30 April 2026

Re: Proposed Deviation from Source Removal Work Plan Rev.1
155 3rd Street (Block: 462 Lot: 12)
Brooklyn, NY
BCP Site No. C224336
Langan Project No.: 170390002

Project	141 3RD STREET BLOCK No. 462, LOT No. 12 BROOKLYN NEW YORK
Figure Title	REMEDIAL PROGRESS PLAN
Project No.	170390001
Date	04/21/2026
Drawn By	GD
Checked By	GN
Figure No.	1

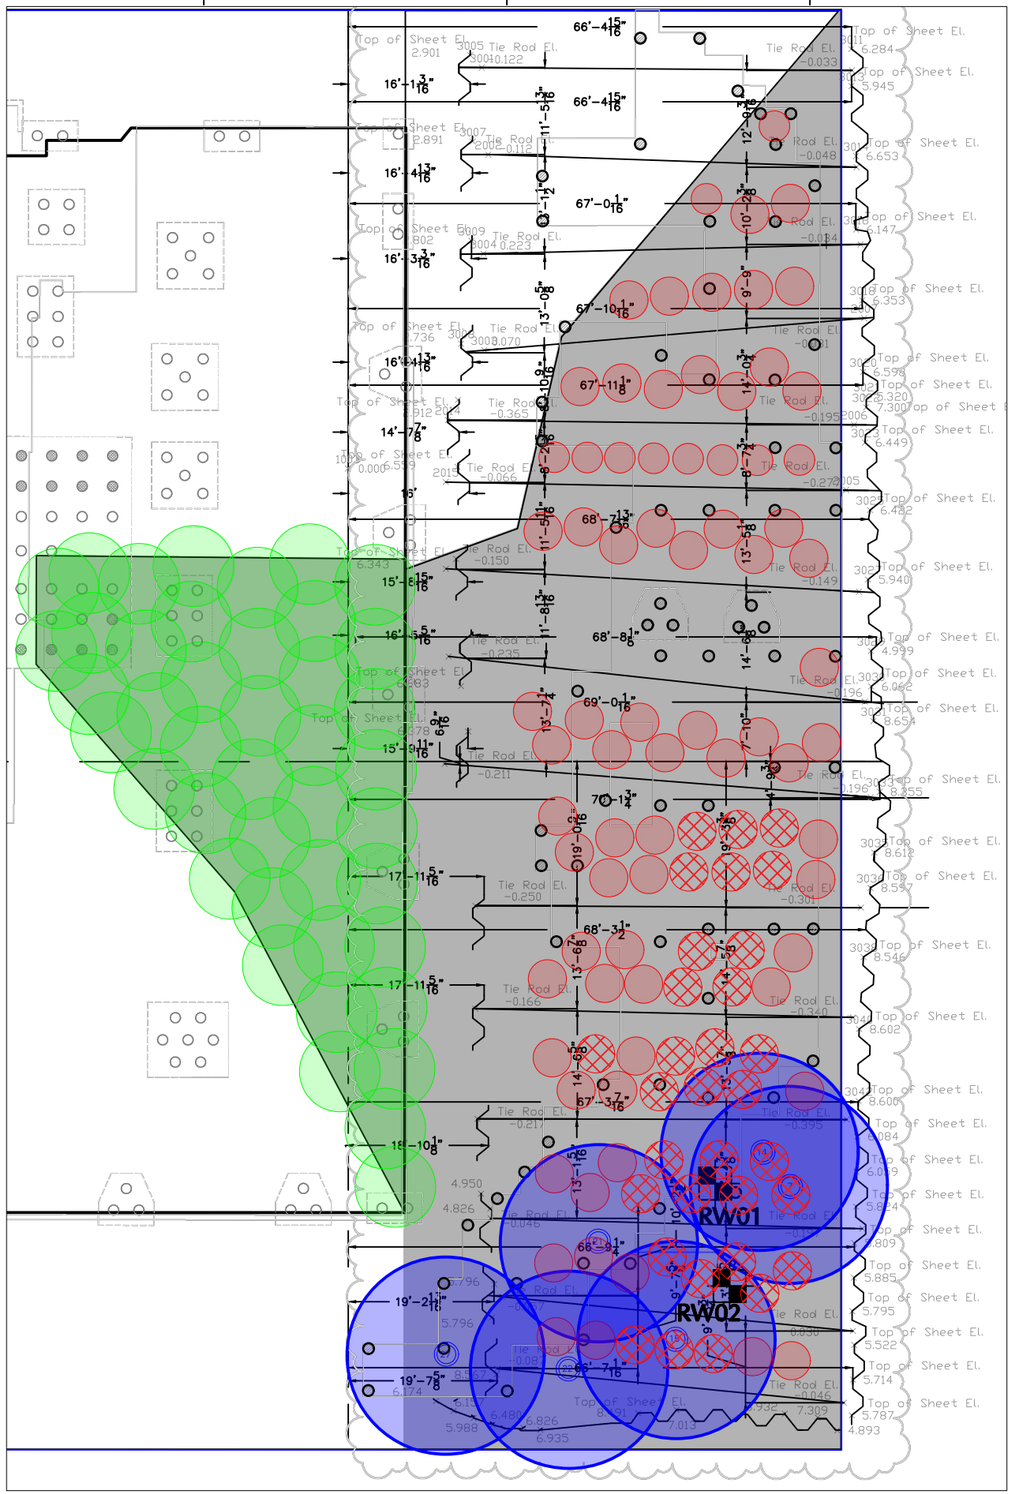
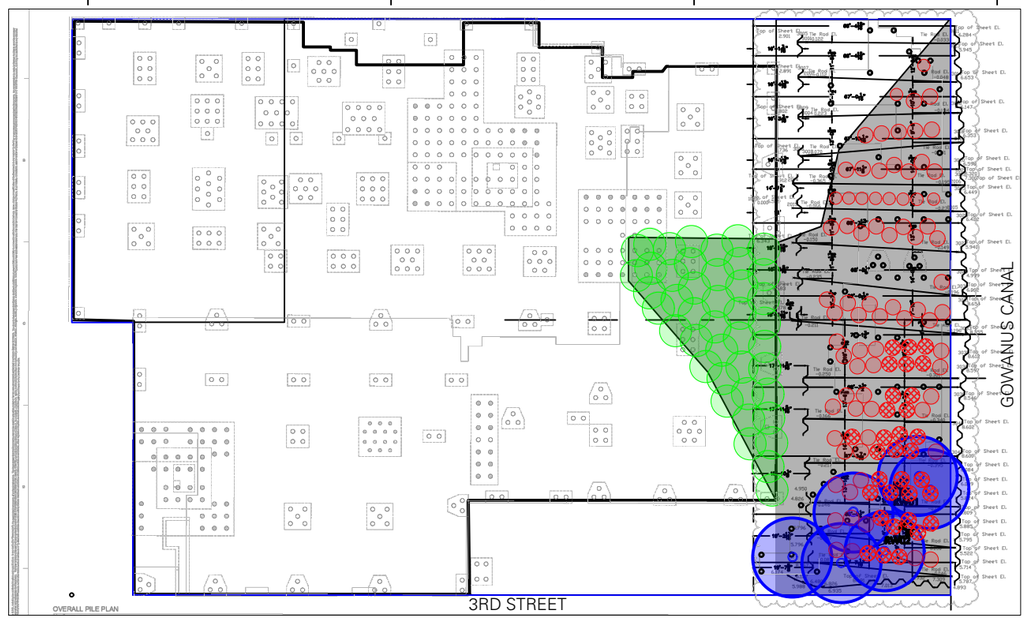
After the above-listed additional controls were implemented, additional movement was documented and all source removal work was stopped on 3 April 2026. Over ¾-inch of additional movement eastward was observed at one point at the top of the bulkhead in one day (two source removal columns). Langan recommended that all source removal work stop and that no further source removal work should be attempted. A total of 75 source removal columns (70%) have been completed of the 107 planned. A plan showing the locations of completed source removal columns is provided as Attachment C.

In addition to the source removal performed, substantial remediation has been performed within the bulkhead area, consisting of a shallow 2-foot excavation and two in situ geochemical stabilization (ISGS) pilot studies. As shown on Attachment C, the ISGS pilot studies generally overlap with the primary area that source removal was limited due to the technical infeasibility described herein.

After multiple attempts to adjust remediation procedures to minimize bulkhead and abutment movement and damage, it has become clear to Langan that the source removal work cannot be completed without imposing significant risk on the stability of the bulkhead and abutment. As such, Langan has determined that it would be unsafe to continue to implement source removal at this site and, as the Engineer of Record for the bulkhead and source removal, Langan can no longer recommend moving forward with any further source removal columns between the bulkhead and the deadmen. The Source Removal Work Plan has been implemented to the extent feasible and the remaining 37 source removal columns cannot be completed. We note that the target source material is ubiquitous below and beyond the remedial extents. The balance of the

remedy prescribed in the Remedial Action Work Plan will continue, with the addition of two recovery wells in the area not subject to source removal as depicted in Attachment C. USEPA has also been informed of our concerns and determination regarding source removal at this site.
